Radiation Safety Associates, Inc.

Re: License No. 06-30007-01
Docket No. 030-33025
Control No. 581256
RSA Laboratories 21 Pendleton Drive Decommissioning Report

ATTACHMENT A

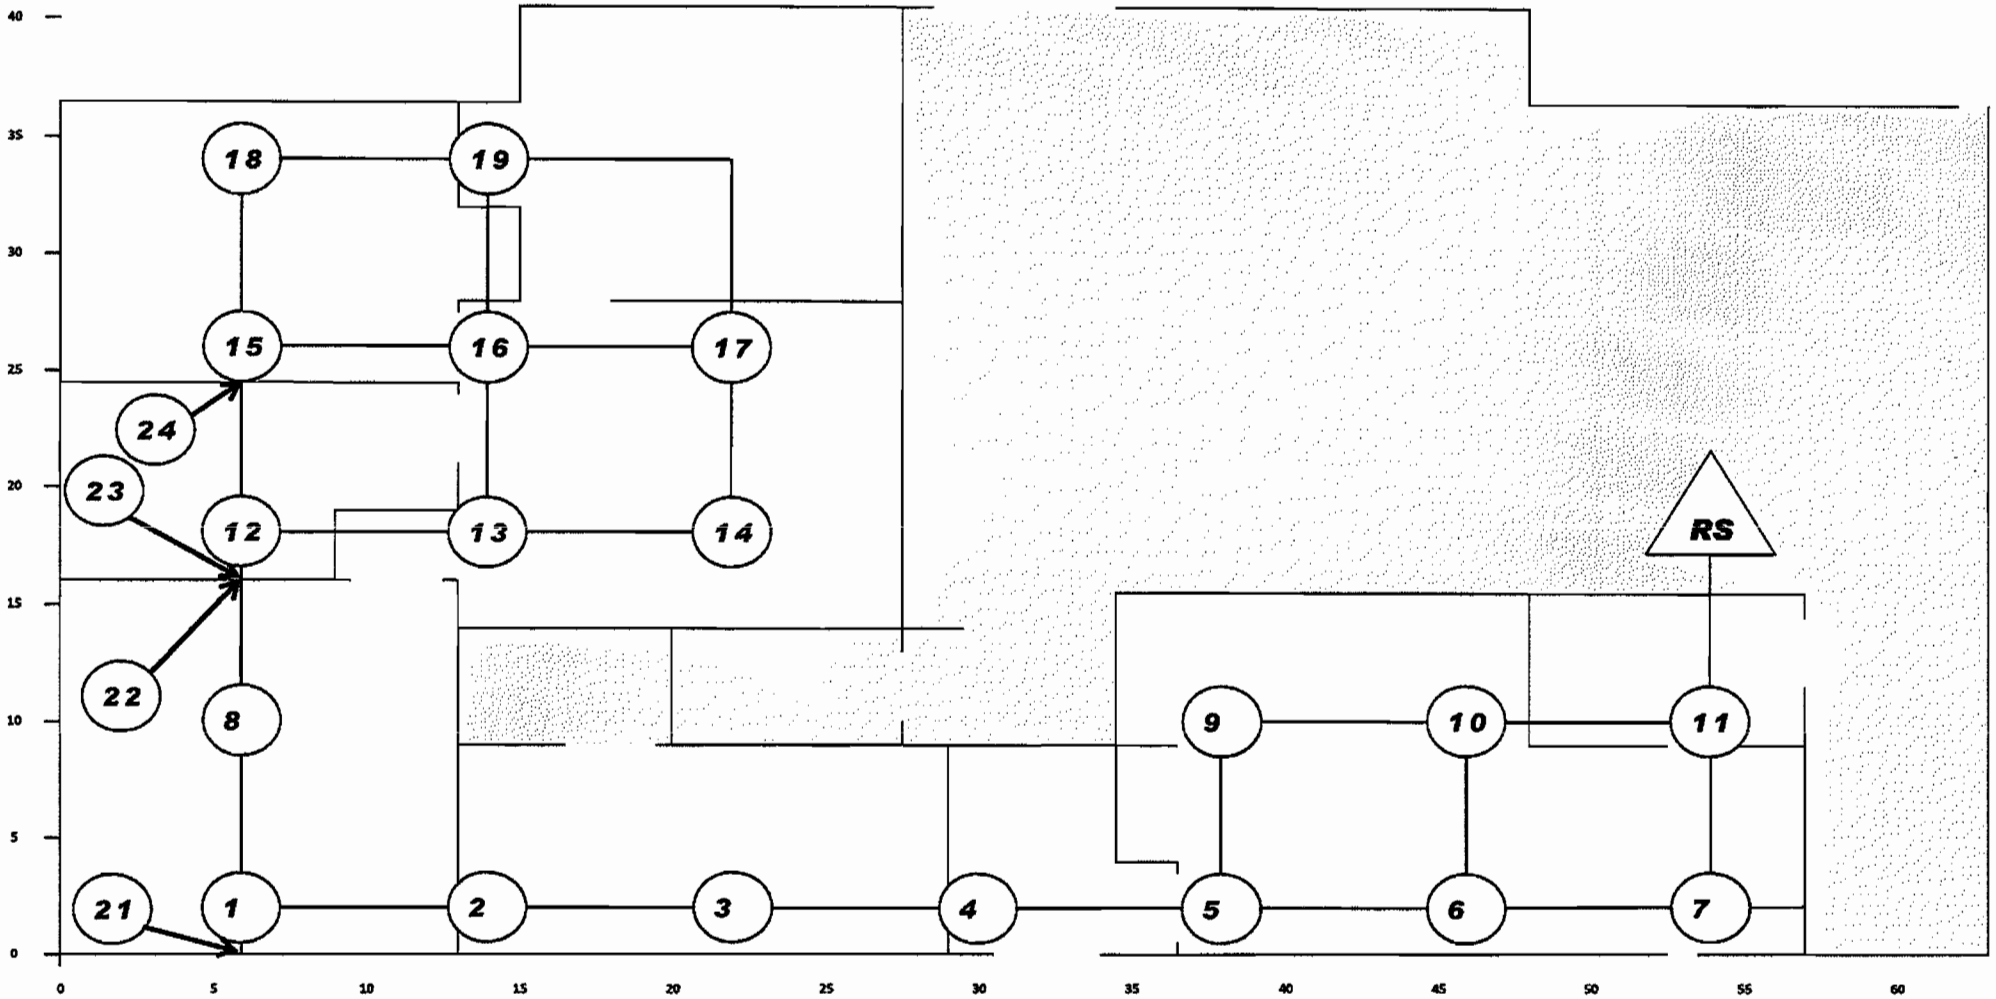
7. Section 9.0 states that the total laboratory area is 118 square meters and is considered a single Class 2 area. However, the direct measurement and scan surveys were performed only of floor areas. Explain if the walls and ceilings were included in the Class 2 area, or should have been included in the Class 2 area. If the walls and ceilings were not part of the Class 2 area, explain their classification and provide any survey information, if applicable.

8. There are 20 samples for alpha/beta direct measurements on pages C-4 and C-5. Confirm if these are the same 1-20 locations as on pages C-2 and C-3. Explain why there are no direct measurements for total residual radioactivity on the walls. Explain which of the 20 floor samples and the 21 wall samples are part of the MARSSIM random start statistical sample points, and which were additional locations you selected to survey. Section 9.3 refers to grid points and random locations, but I cannot tell which are which. What about scan survey results?

3. The walls up to a height of 2 meters above the floor in the Radioactive Materials / Rad Waste Storage Room and the Chemistry Lab/Sample Prep Room have been classified as MARSSIM Class 2. Sampling points on the walls in these two rooms were added to the existing grid by extending the grid to and up the walls.

Response: See the response to question 7. A new map of the MARSSIM sampling points and is attached (Attachment A). The additional wall sampling points are numbers 21 through 24 in the prep room and storage room. Direct measurement results are located on Attachment B (alpha) and C (beta) for all sample points. Wipe results are located on Attachments D (gas proportional analysis for gross alpha/beta) and E (liquid scintillation analysis).
